Department of Energy
Washington, DC 20585

YUCCA MOUNTAIN – REQUEST FOR ADDITIONAL INFORMATION RE: LICENSE APPLICATION (SAFETY ANALYSIS REPORT SECTIONS 2.3.9.2.2 and 2.3.9.2.3), SAFETY EVALUATION REPORT VOLUME 3 – POSTCLOSURE CHAPTER 2.2.1.3.8 – FLOW PATH IN THE SATURATED ZONE, SET 1

RAI: Volume 3, Chapter 2.2.1.3.8, Number 1:

Figure 1-1 Cumulative Normal Probability Plot of Estimated Specific Discharge at the Alluvial Testing Complex

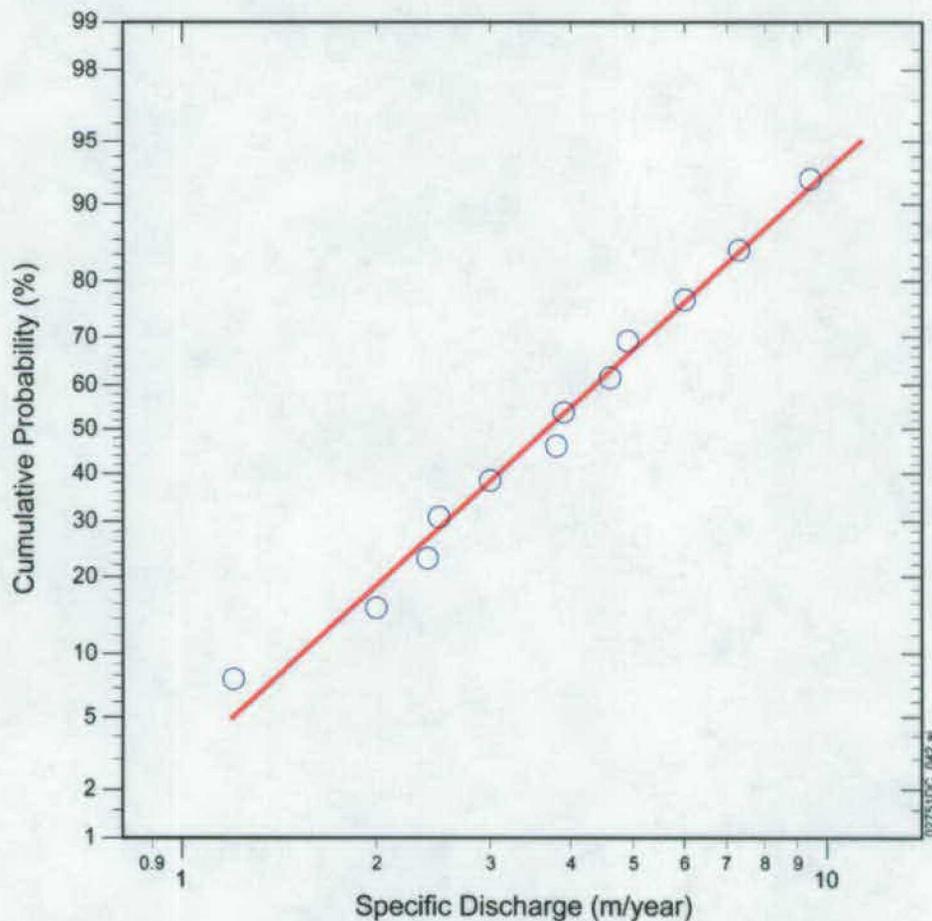
Justify the validity of Bayesian updating of the groundwater specific discharge multiplier using Alluvial Testing Complex data.

Basis: The applicant uses a groundwater specific discharge multiplier (i.e., the GWSPD parameter in Total System Performance Assessment) to propagate uncertainty related to the site-scale specific discharge (SAR Section 2.3.9.2.3.6). The probability distribution of GWSPD was originally provided by an Expert Elicitation Panel (CRWMS M&O, 1998). Based on tracer testing at the Alluvial Testing Complex, 12 specific discharge values (SAR Table 2.3.9-2) were estimated using four interpretation methods. In light of this new information, the applicant applied a Bayesian updating formula to reduce uncertainty in GWSPD, where the probability distribution provided by the Expert Elicitation Panel was treated as a log-normal prior. The applicant then uses the 12 specific discharge data to estimate a log-normal likelihood function, although the applicant states that "some significant uncertainties are associated with each of the estimation methods" (Sandia National Laboratories, 2007b, Appendix G4.4). The applicant needs to justify the validity of assuming the 12 specific discharge estimates as independent and identically distributed random samples from a log-normal distribution, which is an underlying assumption of Bayesian updating (Gelman et al., 2004, Section 2.6).

The distribution of the 12 estimated values of specific discharge used as new information in the Bayesian updating is shown graphically in Figure 1-1. Values of specific discharge are plotted on a log scale along the x axis and cumulative probability is plotted on a normal probability scale along the y axis. A linear plot of the empirical cumulative distribution function on a graph with these axis types indicates a log-normal statistical distribution of the data. The close comparison between the 12 estimated values of specific discharge shown with the open circles and the fitted log-normal distribution shown with the solid line demonstrates that these data are approximately log-normally (and identically) distributed. The conclusion that the estimates of specific discharge are identically distributed is supported by the fact that they conform closely to a single log-normal distribution.

Figure 1.1 Map of Vertical Hydraulic Gradient between the Volcanic Units and the Top of the Paleozoic Aquifer and Cross Section of Simulated Particle Paths

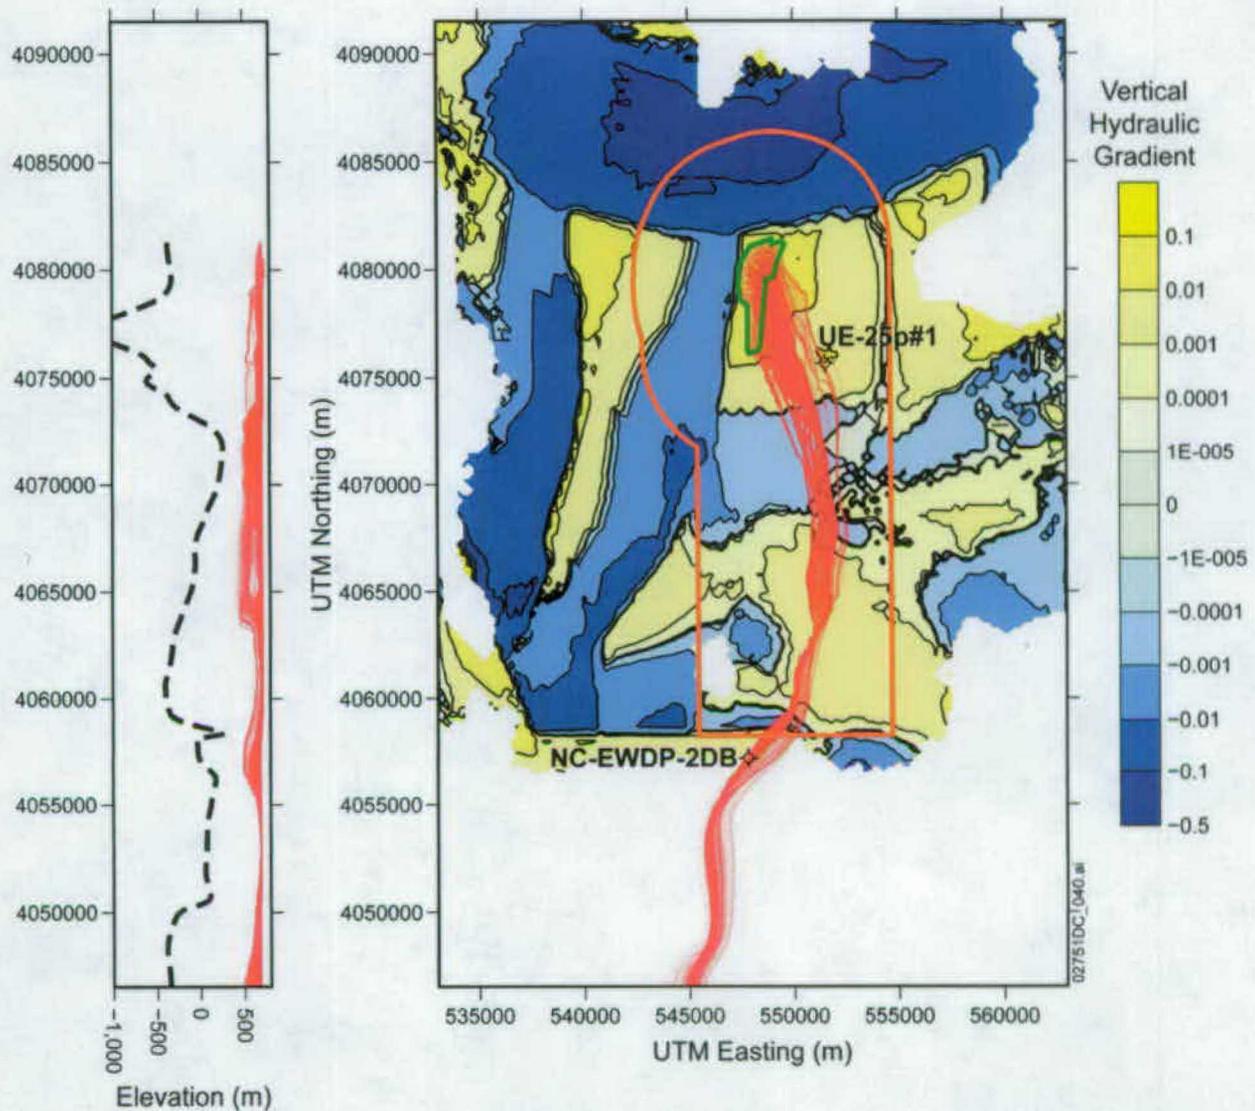
Demonstrate quantitatively that the calibrated site-scale flow model reproduces the upward vertical hydraulic gradient and shows the lateral continuity of the model-simulated upward hydraulic gradient.

Basis: The applicant considers the upward vertical hydraulic gradient from the Paleozoic carbonate aquifer to overlying volcanic aquifers an important barrier to radionuclide transport. The applicant states that “wells showing an upward gradient are assigned a weight of 10 because it is important to reproduce this phenomenon” (SAR Section 2.3.9.2.3.2). Only two boreholes (UE-25 p#1) and NC-EWDP-2DB penetrate the carbonate aquifers. However, neither UE-25 p#1 nor NC-EWDP-2DB is assigned a weight factor of 10 during the calibration process (Sandia National Laboratories, 2007a, Table 6-8).

Contour maps of the vertical hydraulic gradient from the site-scale saturated zone flow model, generated as defined above, along with a cross section of simulated particle paths are shown in Figures 1.1 and 1.2. A positive value indicates an upward gradient and a negative value indicates a downward gradient. Similar patterns of upward and downward vertical gradients are shown for the two methods of calculating the vertical gradient described earlier.

The upward gradient is simulated at the locations of the wells that penetrated the carbonate aquifer, UE-25 p #1 and NC-EWDP-2DB and much of the model domain. Upward vertical hydraulic gradients are simulated to occur for several kilometers to the east and south of the repository. After crossing one area in which the vertical gradient is downward, the simulated flow paths are generally located in areas of upward vertical gradient to the boundary of the accessible environment and to the boundary of the site-scale model domain. Downward simulated gradients are noted in the area to the north of the steep hydraulic gradient in the northern part of the domain and to the west of the Solitario Canyon fault, which are located away from the predominant flow paths originating beneath the repository.

The patterns of upward and downward vertical hydraulic gradients shown in Figures 1.1 and 1.2 are consistent with the principles of regional groundwater flow, the boundary conditions for the site-scale saturated zone flow model, and the hydrogeologic framework model. Strong downward vertical gradients are simulated to occur in areas of lower permeability and greater recharge (SNL 2007, Figures 6-12 and 6-14) in the area to the north of the repository, as expected. Upward vertical gradients are simulated over much of the area to the south of Yucca Mountain, particularly along most of the inferred flow paths from beneath the repository to the south southeast and then to the south. This pattern of downward hydraulic gradients in areas of regional recharge and upward gradients further along regional flow paths is typical of large-scale regional flow systems (Freeze and Cherry 1979, Section 6.1). Several areas of simulated downward vertical gradient shown in Figures 1.1 and 1.2, such as to the west of the Solitario Canyon fault, to the east of the Bare Mountain fault, and to the north of the Highway 95 fault, occur on the upstream side of the associated low-permeability faults (SNL 2007, Figure 6-12), which act to impede horizontal groundwater flow.

The east-west zone of simulated downward hydraulic gradient along the flow path from beneath the repository (approximately at 4069000 to 4074000 m UTM northing) is associated with a relatively high upper surface of the Paleozoic units, as shown on the cross sections in Figures 1.1 and 1.2. This higher area on the Paleozoic surface consists of the thrustured LCA_T1 hydrogeologic unit (SNL 2007, Figure 6-8), which has a high calibrated value of permeability relative to the overlying volcanic hydrogeologic units (SNL 2007, Table 6-9). The higher permeability of the LCA_T1 unit provides a pathway for flow and lateral continuity with the deeper and thicker LCA unit to the south (SNL 2007, Figure 6-8), creating the moderate downward vertical hydraulic gradient in this area of the site-scale saturated zone flow model. Although there is some downward movement of simulated particle flow paths evident in this area and further to the south in the cross sections in Figures 1.1 and 1.2, this downward vertical gradient does not cause flow paths from beneath Yucca Mountain to enter the LCA_T1 or LCA units. The values of vertical hydraulic gradient plotted in the maps of Figures 1.1 and 1.2 are average values that are calculated over varying thicknesses, whereas simulated flow paths are a function of the local vertical gradients along the flow path. There are several areas of downward vertical gradients and mixed gradients in the southeastern part of the model domain shown in Figure 1.2 that are related to complexity of the hydrogeologic framework model in this area of the site-scale saturated zone flow model and the presence of the higher-permeability LCA_T1 unit.
